Summary of Comments on 121328205_PAA review 01-26-17.pdf

Page: 48

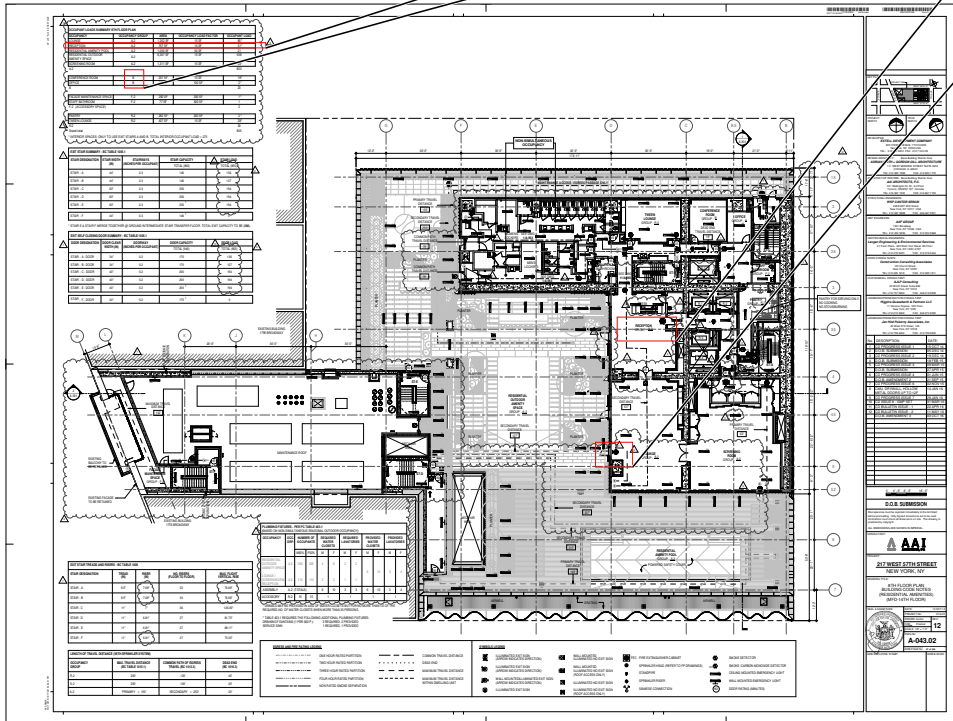
Author: dtitus Subject: Rectangle Date: 1/26/2017 12:41:00 PM
remove occupant load for reception area.

Author: dtitus Subject: Rectangle Date: 1/26/2017 12:26:11 PM
Accessory to residential use. Please indicate as R-2

Author: dtitus Subject: Rectangle Date: 1/26/2017 12:33:29 PM
Indicate as non-simultaneous occupancy.

Provide note: non-simultaneous to lounge and screening room.

Author: dtitus Subject: Rectangle Date: 1/26/2017 12:37:07 PM
Exit not permitted unless non-simultaneous reception, lounge and screening room becomes one PA with the outdoor area.

Page: 70

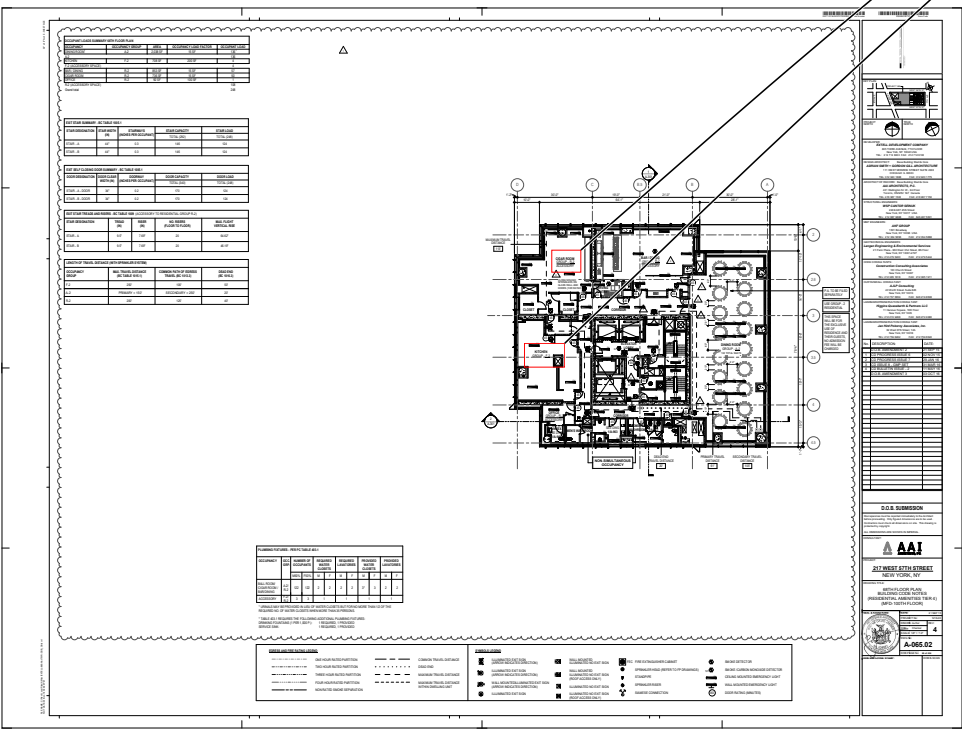
Author: dtitus Subject: Rectangle Date: 1/26/2017 12:50:11 PM
cigar room: Provide net area of space and number of persons to be accommodated based on 15 sq. ft./person as per Table BC 1004.1.1.

Author: dtitus Subject: Rectangle Date: 1/26/2017 12:52:09 PM
Commercial kitchens need not be separated from the restaurant seating areas that they serve as per Table 508.4.4, provided:
1. The cooking equipment is vented directly to the outdoors; and
3. Fire protection systems in accordance with the provisions of Section 903 and 904 are provided on the cooking facilities side of the curtain, or any opening between the kitchen and dining space, located within 24 inches (609 mm) of the curtain or opening, and spaced not more than 48 inches (1219 mm) on center if the opening is more than 60 inches (1524 mm) wide.

BC 903.2.11.9 Commercial cooking operations. An automatic sprinkler system shall not be installed in a commercial kitchen exhaust hood and duct system. Fire extinguishing systems shall be installed in commercial cooking systems in accordance with Section 904.11.

BC 904.2.1 Hood system suppression. Each required commercial kitchen exhaust hood and duct system required by the New York City Fire Code or the New York City Mechanical Code to have a Type I hood shall be protected with an approved automatic fire-extinguishing system installed in accordance with this code.

Kitchen shall also comply with MC 506, 507, and 508; PC 802.1.7 and 1003.3.1. Please verify on MH/PL plans.

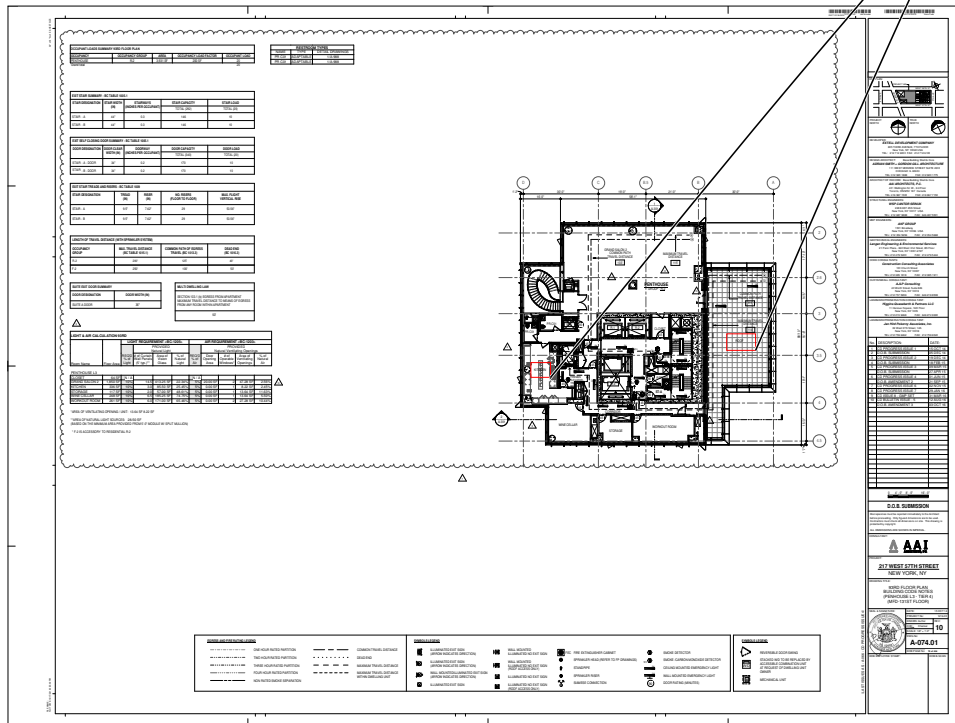
Provide net area of space and number of persons to be accommodated based on (15) sq. ft./person as per table BC 1004.1.1. (roof acc. to all tenants) or provide note: private roof terrace acc. to penthouse unit.

2nd kitchen not permitted if proposed for penthouse.

Commercial kitchens need not be separated from the restaurant seating areas that they serve as per Table 508.4.4, provided:

1. The cooking equipment is vented directly to the outdoors; and
3. Fire protection systems in accordance with the provisions of Section 903 and 904 are provided on the cooking facilities side of the curtain, or any opening between the kitchen and dining space, located within 24 inches (609 mm) of the curtain or opening, and spaced not more than 48 inches (1219 mm) on center if the opening is more than 60 inches (1524 mm) wide.

BC 903.2.11.9 Commercial cooking operations. An automatic sprinkler system shall not be installed in a commercial kitchen exhaust hood and duct system. Fire extinguishing systems shall be installed in commercial cooking systems in accordance with Section 904.11.

BC 904.2.1 Hood system suppression. Each required commercial kitchen exhaust hood and duct system required by the New York City Fire Code or the New York City Mechanical Code to have a Type I hood shall be protected with an approved automatic fire-extinguishing system installed in accordance with this code.

Kitchen shall also comply with MC 506, 507, and 508; PC 802.1.7 and 1003.3.1. Please verify on MH/PL plans.
